Item Name: Fwd Crosstube

D206-667-101/112789

DRAWING NO. D206-667-141	TITLE CROSSTUBE ASS'Y (206B HIGH FWD)	REV. C	DART AEROSPACE LTD ENGINEERING ORDER		D.E.O. NO. D206-667-141-C-1	SHEET NO. SHEET 1 OF 1	SCALE NTS
DRAWN 9	CHECKED ASS	MFG. APPR. AD	APPROVED MD		DE APPR. A		
DATE 11.07.15	DATE 11.07.20	DATE 11.07.21	DATE 11/07/21		DATE 11.07.21

DRAWING NO. D206-667-141	TITLE CROSSTUBE ASS'Y (206B HIGH FWD)	REV. C	DART AEROSPACE LTD ENGINEERING ORDER		D.E.O. NO. D206-667-141-C-2	SHEET NO. SHEET 1 OF 1	SCALE NTS
DRAWN AJS	CHECKED	MFG. APPR.	APPROVED		DE APPR.		
DATE 12.08.02	DATE 12.08.02	DATE 12.08.02	DATE 12.08.02		DATE 12.08.02

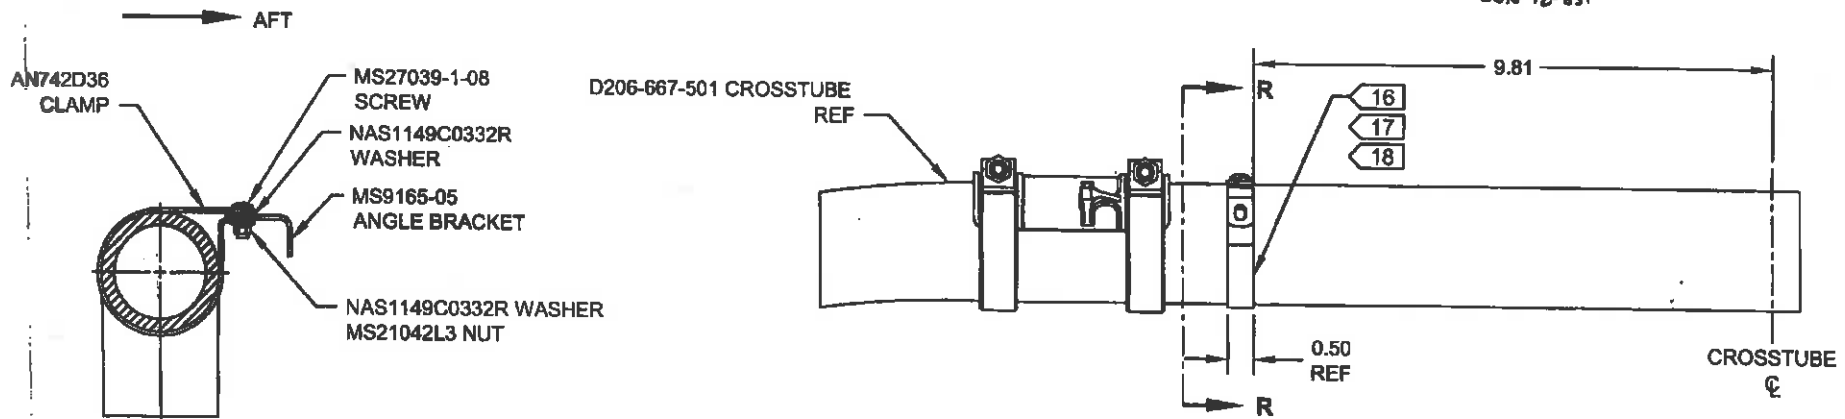
ADD ELECTRICAL GROUNDING STRAP

CHANGE:

PARTS LIST:

ITEM	QTY	PART NUMBER	DESCRIPTION
1	X	D206-667-141	CROSSTUBE ASSEMBLY (206B HIGH FWD)
10	2	AN742D36	CLAMP
11	2	MS9165-05	ANGLE BRACKET
12	2	MS21042L3	NUT (OR MS21042-3)
13	2	MS27039-1-08	SCREW
14	4	NAS1149C0332R	WASHER (OR AN960C10L)

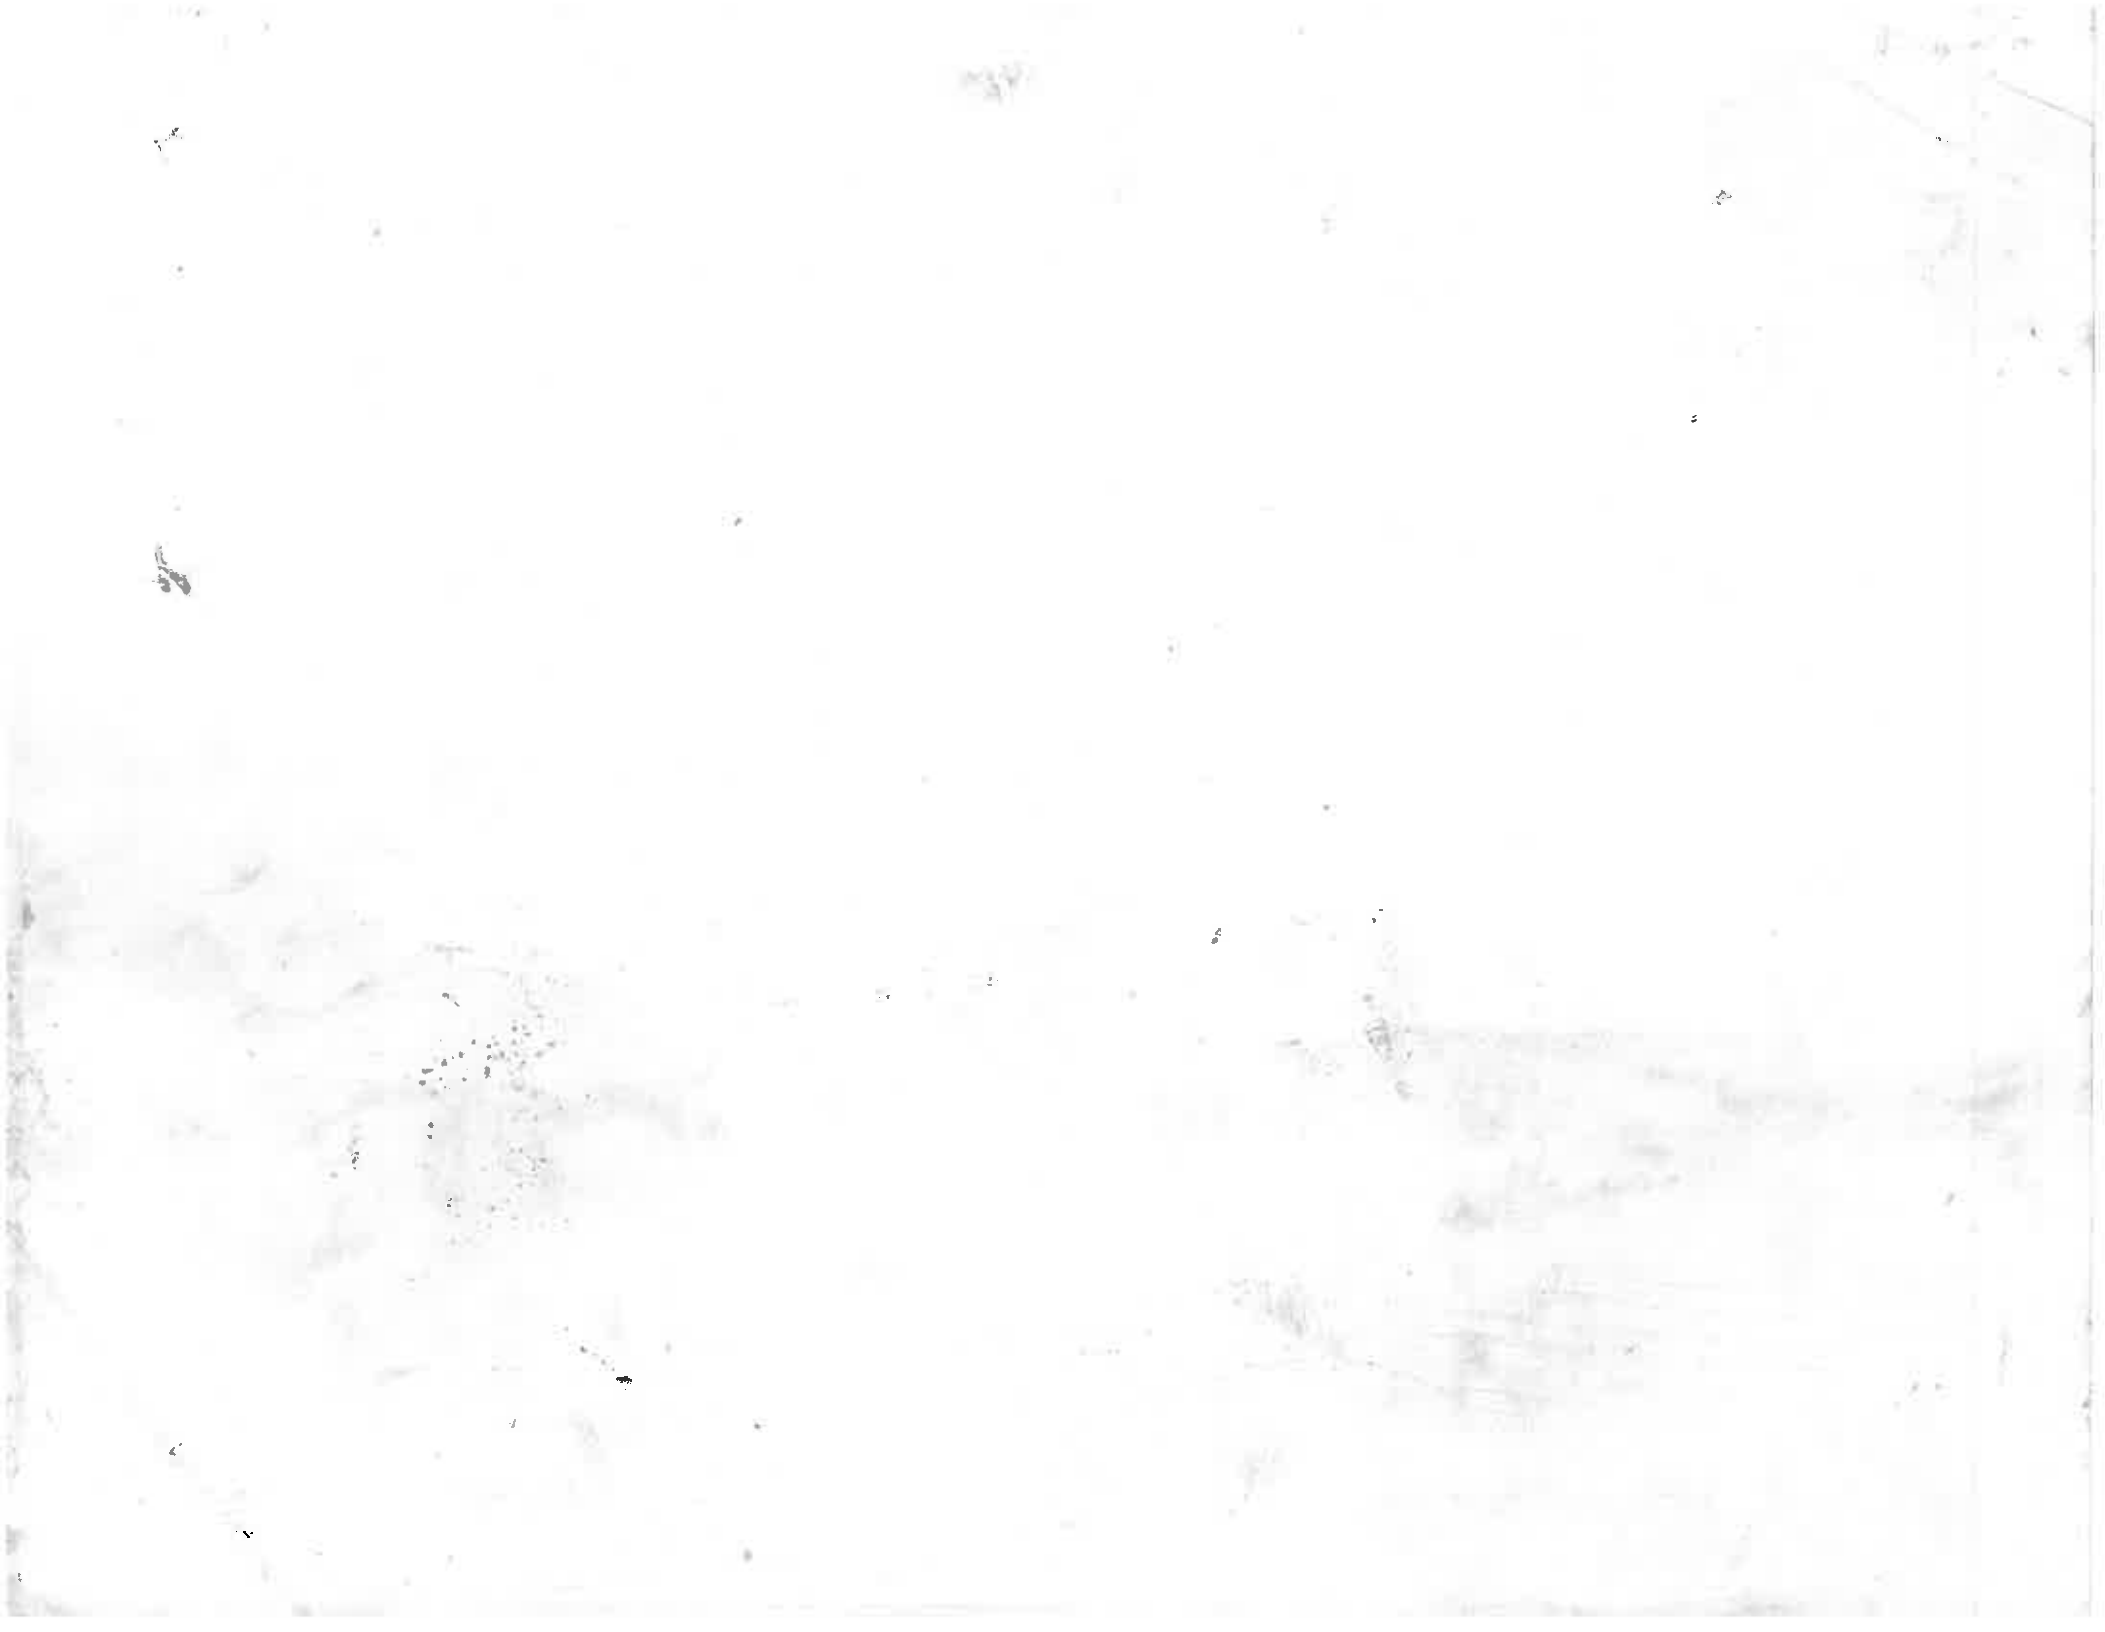
CHANGE:

For the crosstubes listed above, section 32.4 of ICA-D206-667 is amended as follows. Use Figures 32-4 to 32-8 of ICA-D206-667 for further reference. For crosstubes of an earlier change number, it is recommended that if the supports are removed, the supports should be reinstalled using the procedure listed below.

- 32.4.2 If present, remove any paint/primer on bottom of supports. Abrade mating surfaces of support and crosstube with 400-grit sandpaper. Saturate a clean cloth with MEK or 4105S Wash'n'Wipe Degreaser or equivalent and wipe until there is no residue.
